Action Taken: Conditionally approved Sign Review Permit SR-4-01 per the staff memorandum with attachments, via adoption of Resolution SR-4-01.

Action Taken: Conditionally approved Sign Review Permit SR-1-01 per the staff memorandum with attachments, via adoption of Resolution SR-1-01.

MEMORANDUM

Subject: Proposed Signage Plan at Brisbane Technology Park

PROPOSED ENTRY MONUMENT SIGN AT CORNER

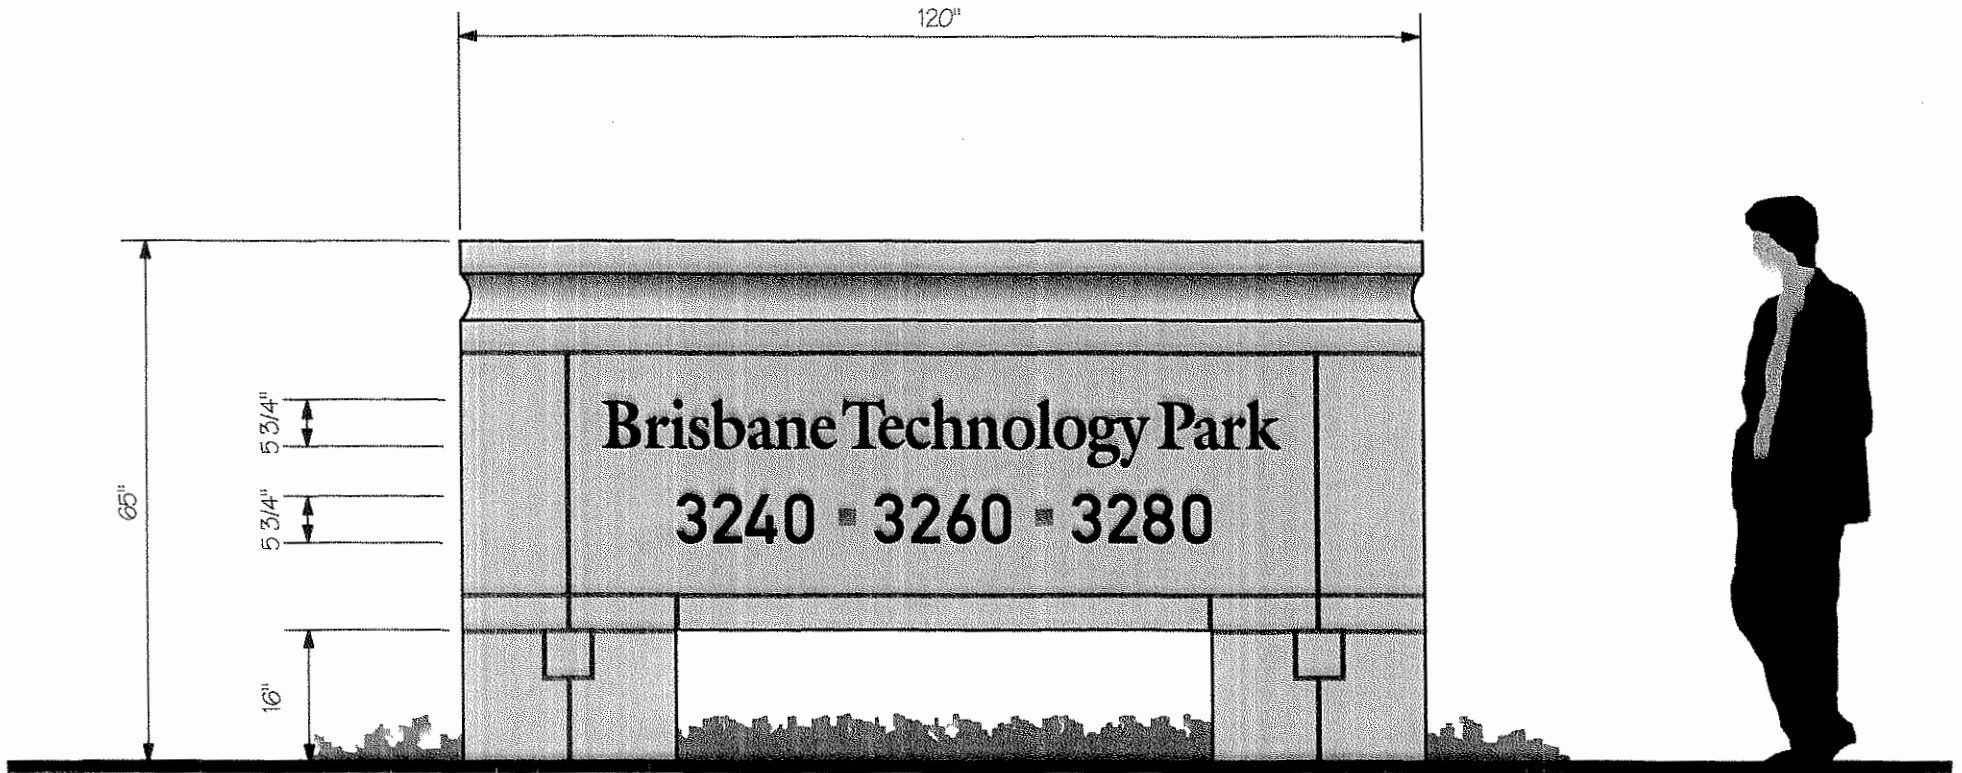
- C. A diagram prepared by a California-licensed registered professional engineer, demonstrating that the height and location of the freestanding signs are outside the sight distance envelope at the street/driveway and street/street intersections, shall be submitted prior to installation of the signs. All signage shall be located on site and not within the public right-of-way.

This intersection is currently signalized and the proposed sign located approximately 15 feet from the curb on Guadalupe Canyon Parkway. The sign will not be located with the sight envelope of any driver and therefore would not affect sight distance at this location.

PROPOSED TENANT DIRECTORY SIGN AT DRIVEWAY ENTRANCES • 2 REQ'D

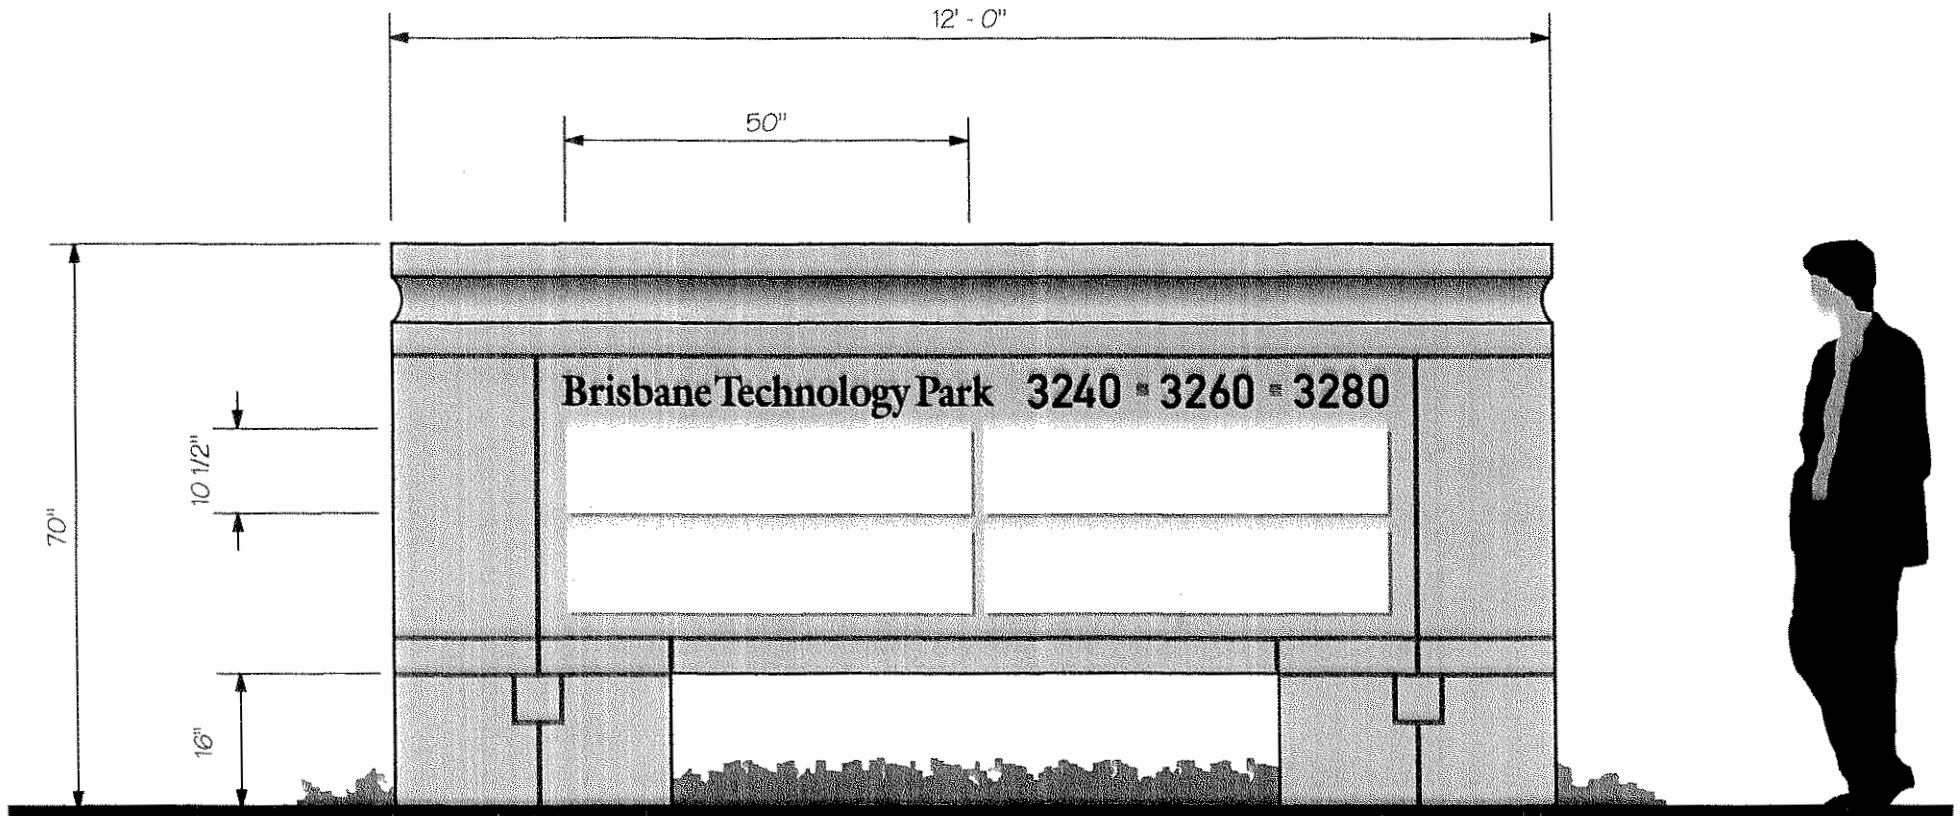
- A. A total of 150 sq. ft. of advertising signage is permitted under the Sign Program.
- B. The freestanding signs shall be revised to the satisfaction of the Fire Prevention Officer to include the street name, Bayshore Boulevard, with the address numbers.

The proposed sign is located 25 feet behind the stop bar at the edge of the separate right turn lane. Since a driver turning left at this location will be located approximately eight feet behind the stop bar, the proposed sign will not impede the view of approaching southbound traffic on Bayshore Boulevard. Thus, adequate sight distance will be provided based on the proposed sign location.

Exhibit B
Line of Sight Diagram

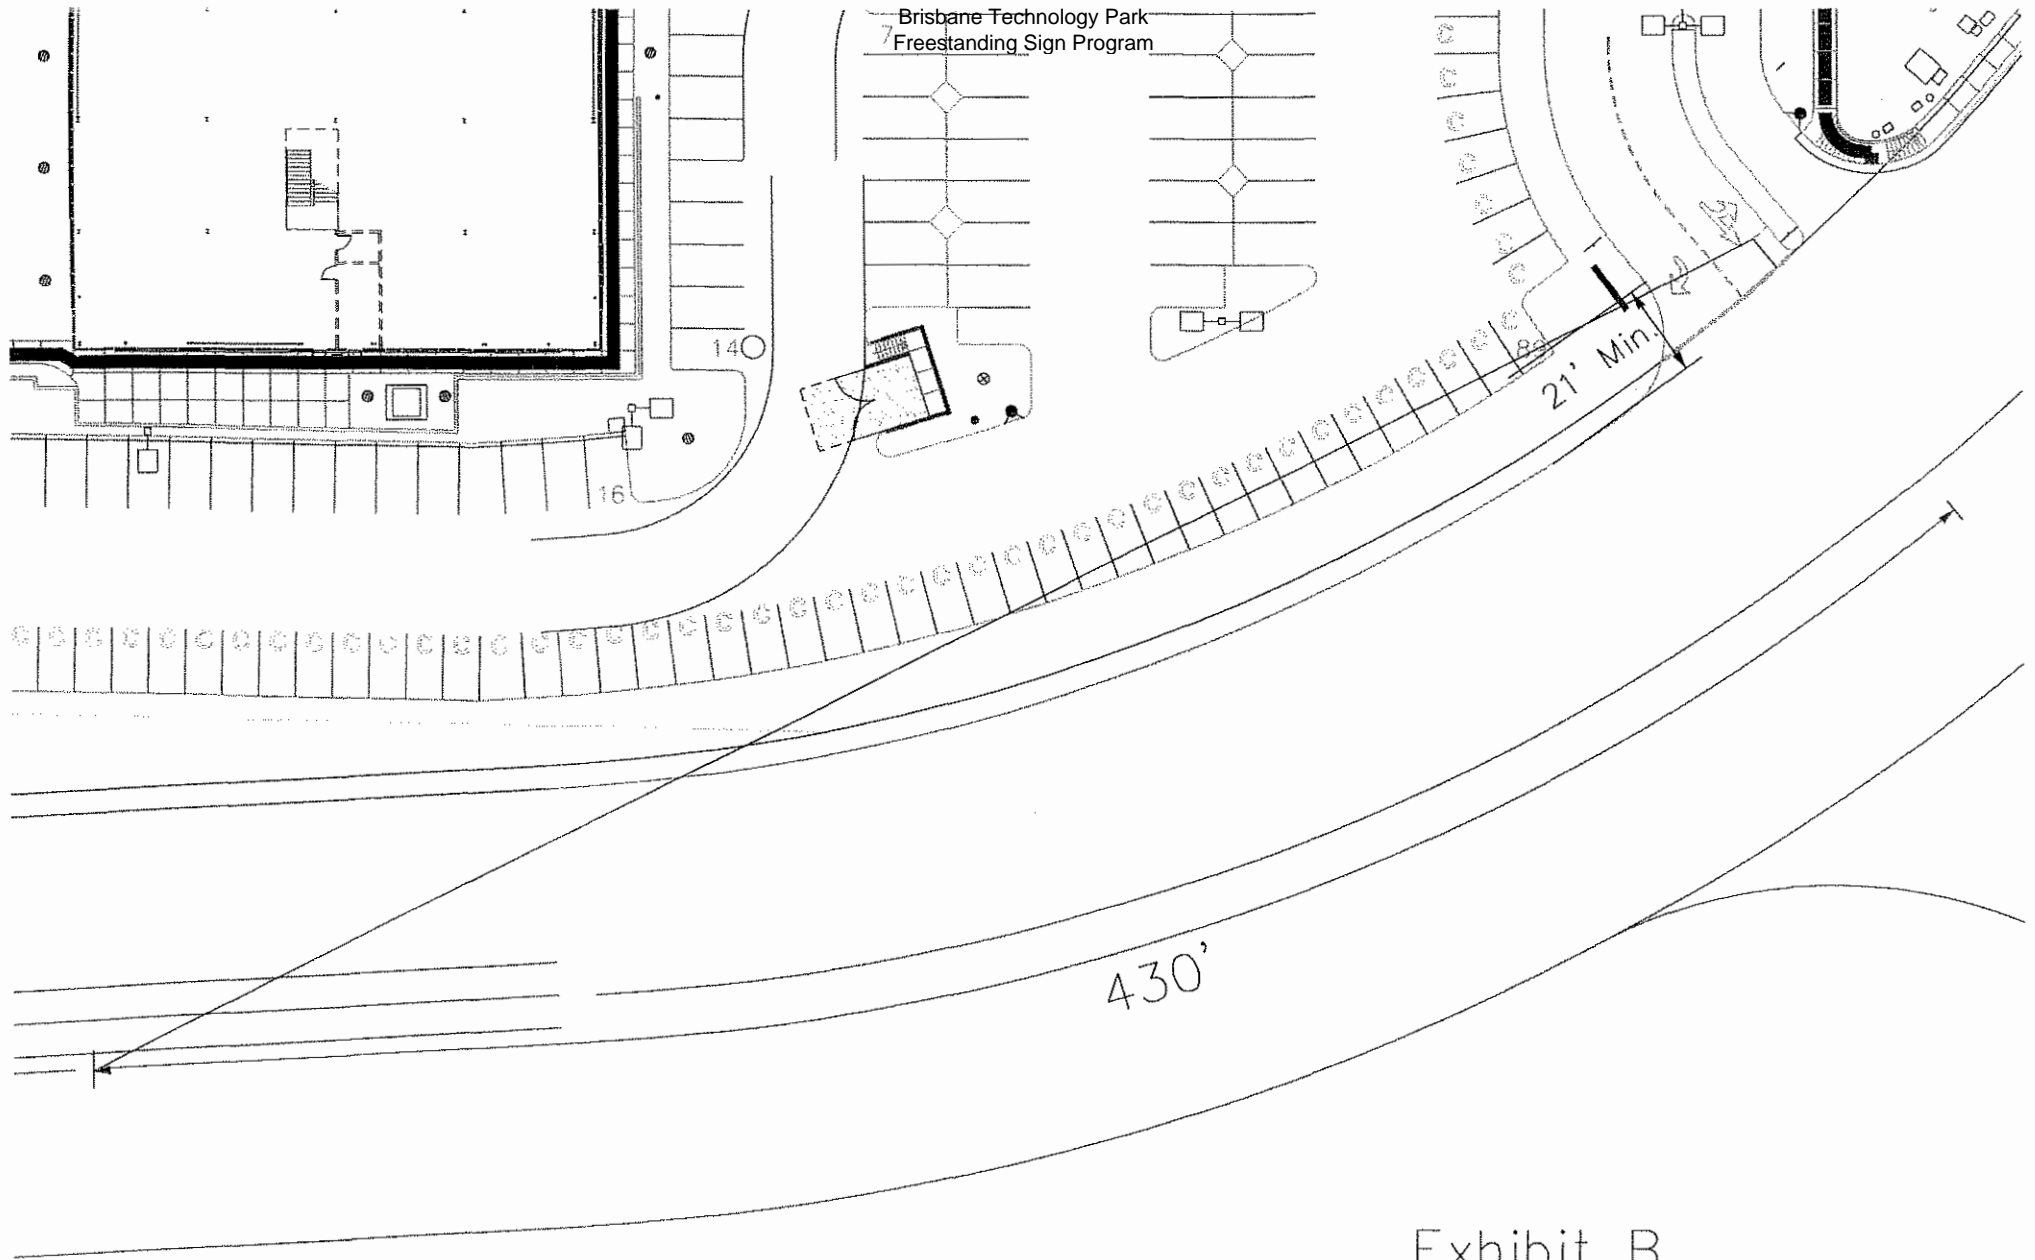
- The signs located at the Bayshore Boulevard driveway and near the Guadalupe Canyon Parkway intersection do not impact the sight distance of vehicle drivers on- or off-site.
- The sign located at the site driveway opposite North Hill Drive does encroach into the sight distance envelope for drivers turning left out of the site; however, this is not considered a problem since the intersection is signalized and vehicles turning left out of the site would be protected by an exclusive signal phase.
- To ensure that the sign at the North Hill Drive exit is outside the sight distance envelope, it should be located no less than 21 feet from the face of curb on Guadalupe Canyon Road.

To meet the sight distance requirements, a driver turning left out of the site should be able to see an eastbound vehicle traveling downhill on Guadalupe Canyon Parkway. A stopping sight distance of 360 feet for eastbound traffic on Guadalupe Canyon Parkway was calculated based on a design speed of 45 miles per hour. However, this distance was increased by 20 percent to approximately 430 feet to account for the downhill grade. For a

vehicle turning left out of the site at this driveway, the proposed sign should be located at least 21 feet from the face of curb on Guadalupe Canyon Parkway as shown on Exhibit B. Relocation would ensure that the sign would not encroach into the sight distance envelope and would account for any red light violations by eastbound Guadalupe Canyon Parkway traffic or for any emergency signal operation.
